Final Supplemental Environmental Impact Report

Gateway South Office Building and Fire Station

City of Scotts Valley

September 2005

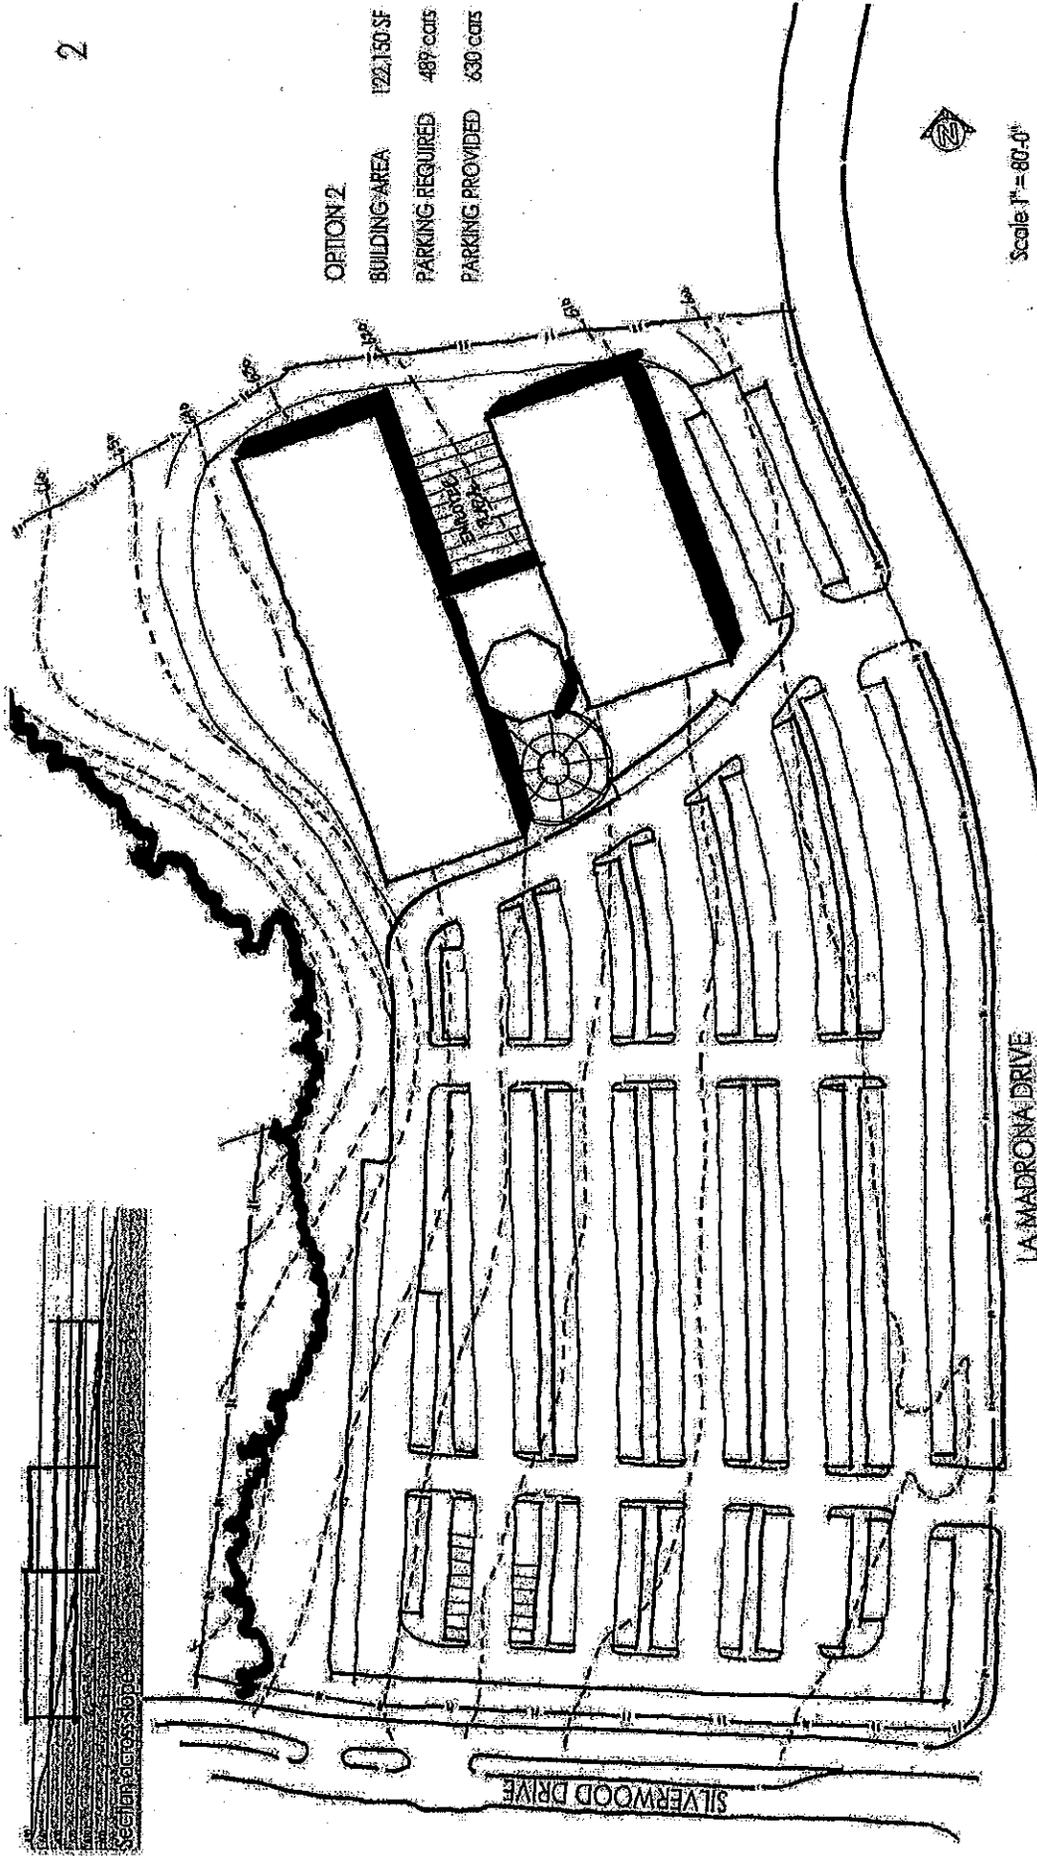
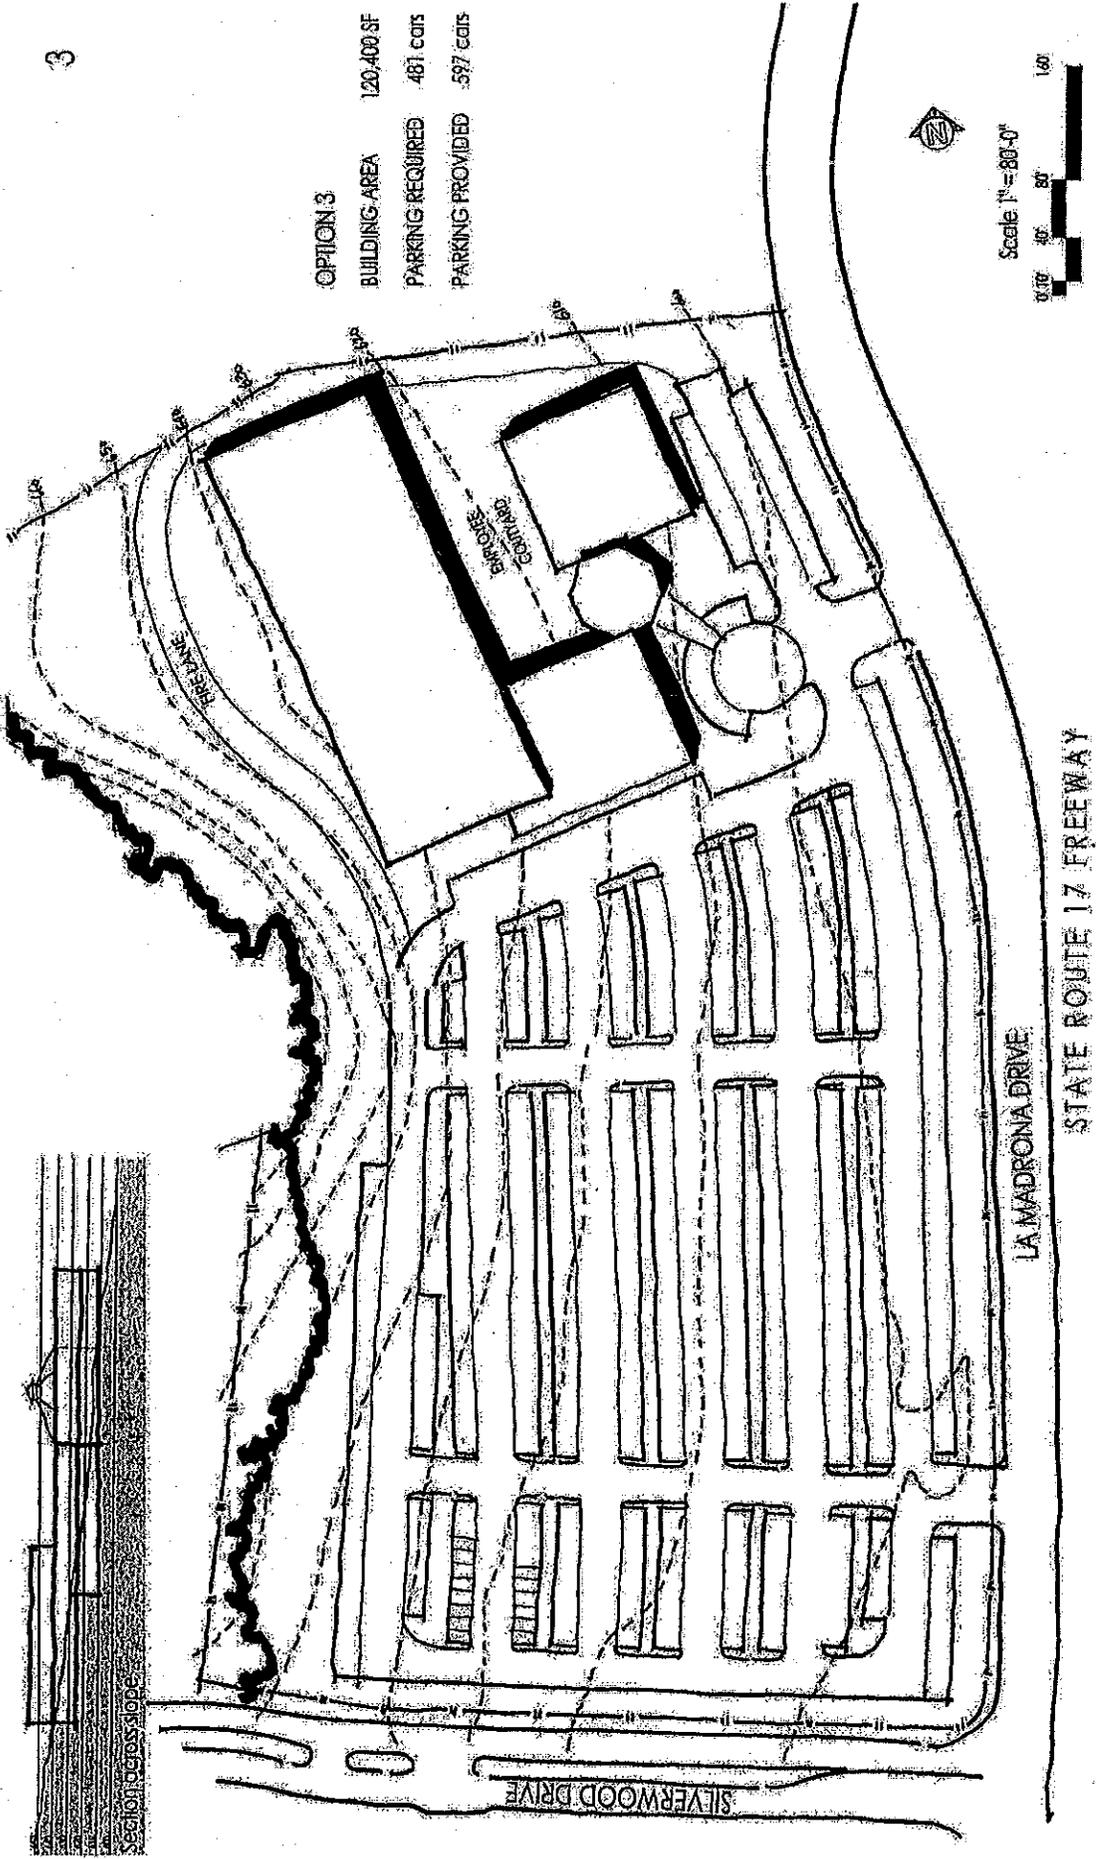
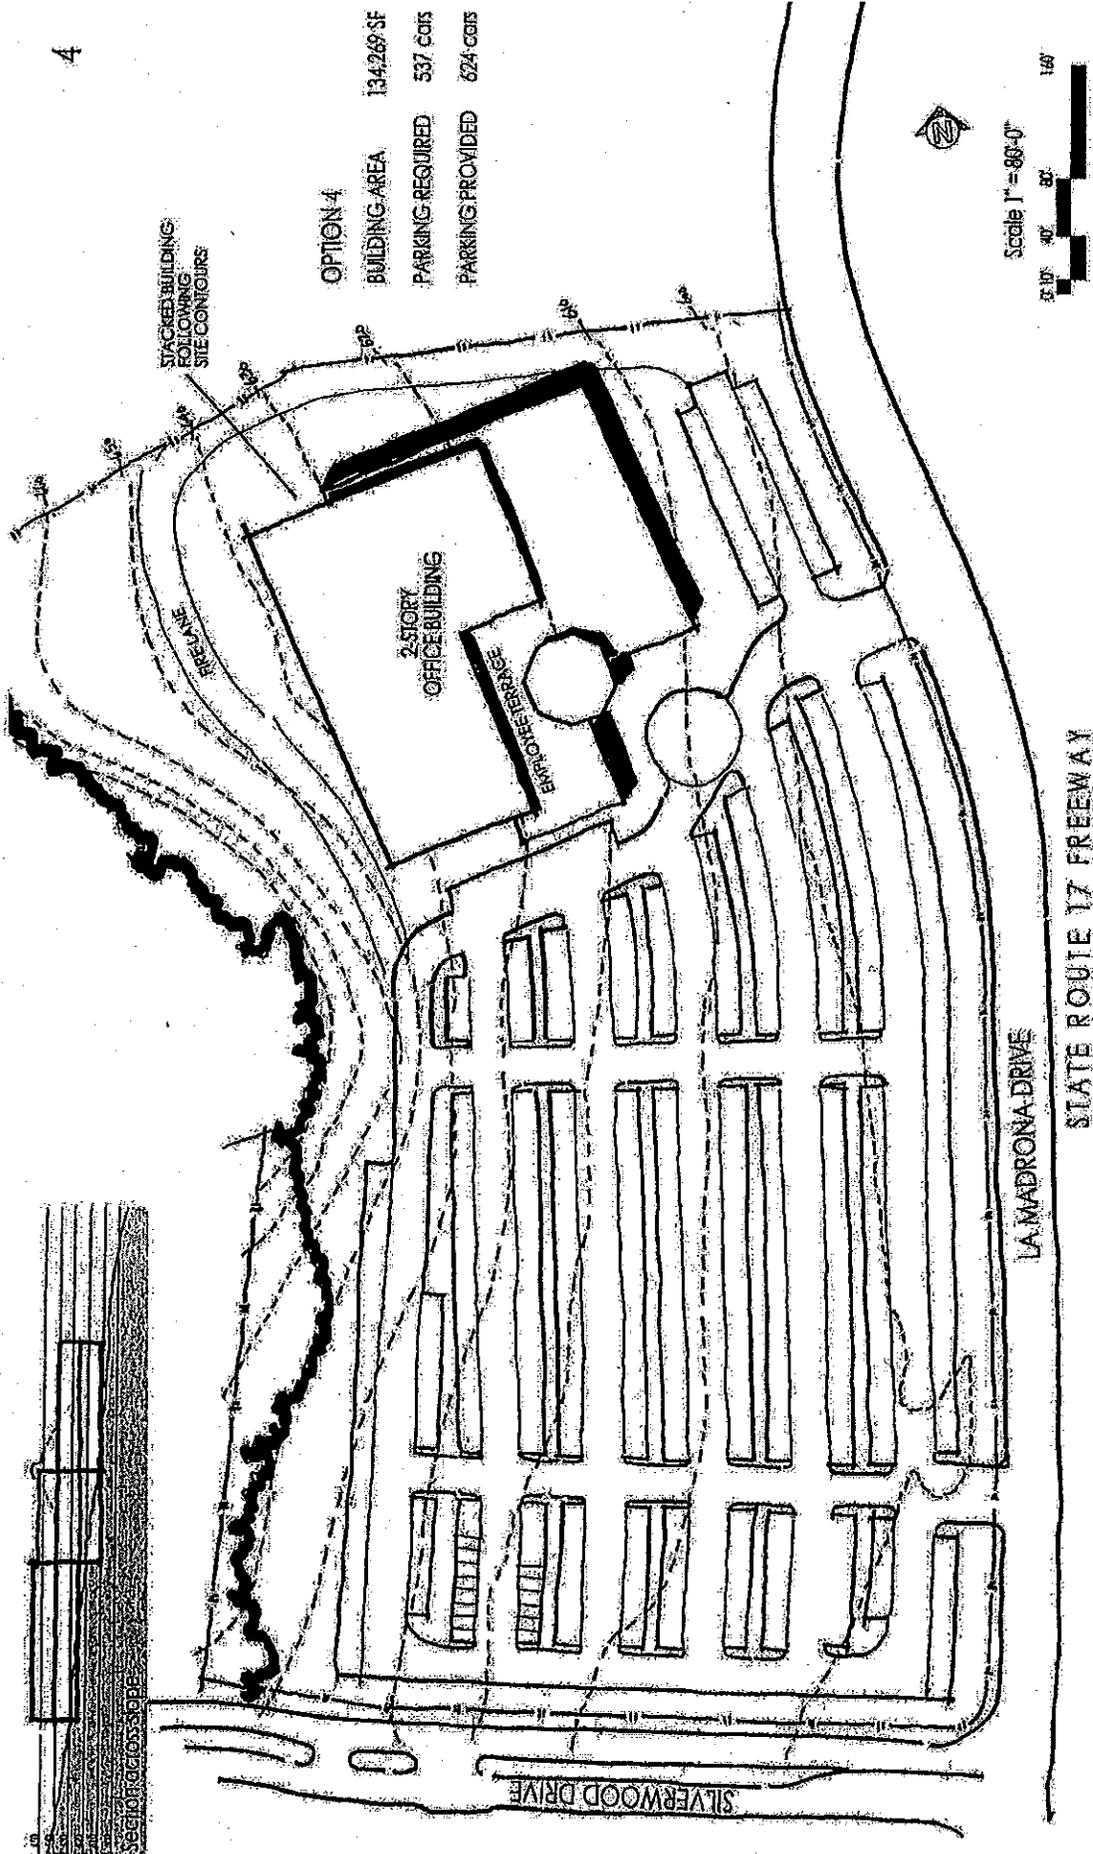
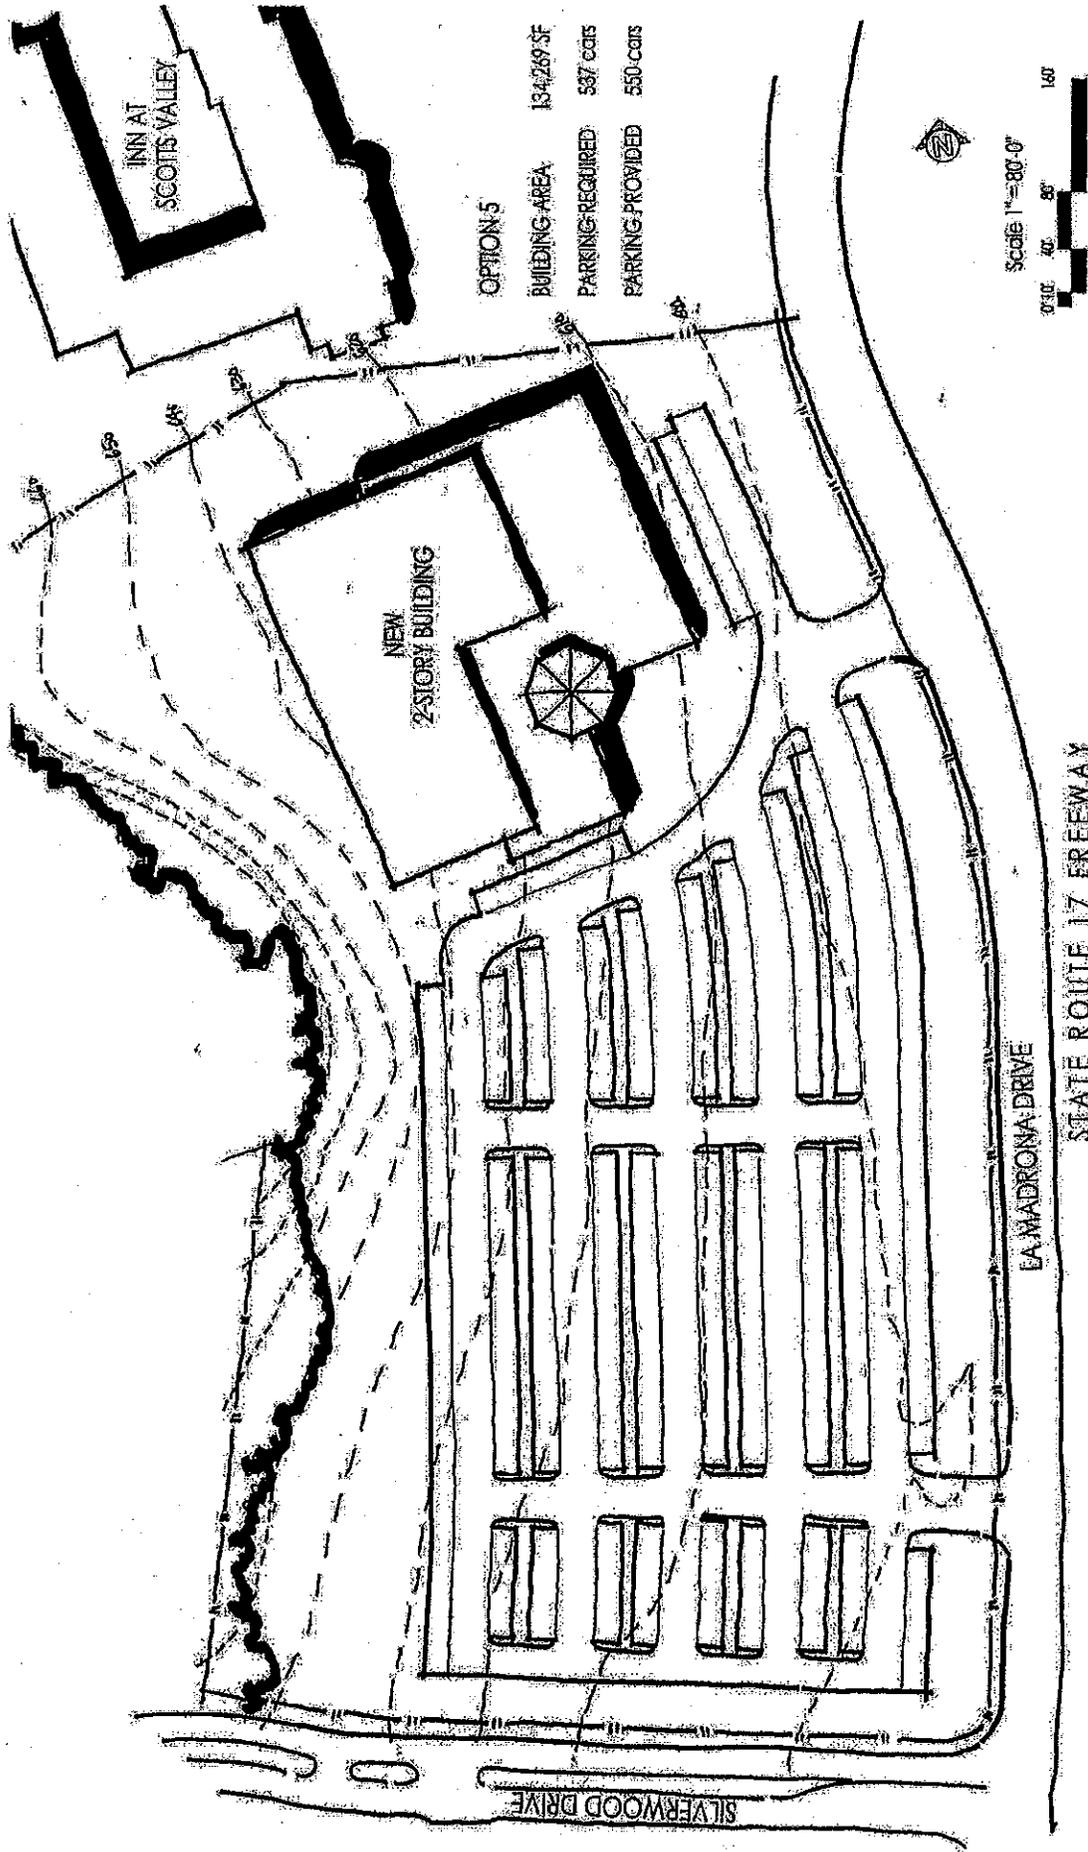
15. Please expand the discussion of alternatives. Couldn't there be an alternative that reduces some of the impacts; e.g., reducing the amount of impervious surface, possibly by providing underground parking; locating the building closer to the Hilton Hotel so that the developments are seen as a visually integrated, cohesive unit; and reducing the amount of cut and fill on the site?

Response: The examination of alternatives as required by CEQA Guidelines, Section 15126.6, includes consideration of other ways of feasibly attaining most of the basic objectives of the project and avoiding or substantially lessening any of the significant effects of the project. In response to the comment to explore other development options, the project architects, DES, developed design options based on suggestions from the Commissioners and Councilmembers. These alternatives are summarized below and illustrated in the following figures labeled Option 1 through Option 6.

While there are notable planning and design differences among these options (stemming from the variations in massing and the ease of accessibility of the building from the parking areas), they result in similar less-than-significant impacts on visual resources and quality. Those options involving more grading than the proposed project have potentially greater runoff and geoseismic impacts. In addition, development of the proposed office building at the northern end of the site raises greater concerns for two issues: fire hazards and disturbance to protected trees. According to the Fire Department, the options of siting the office building closer to the Hilton Hotel would increase the potential for fire to spread between the buildings and to the surrounding grasslands. The northern end of the site between 640 and
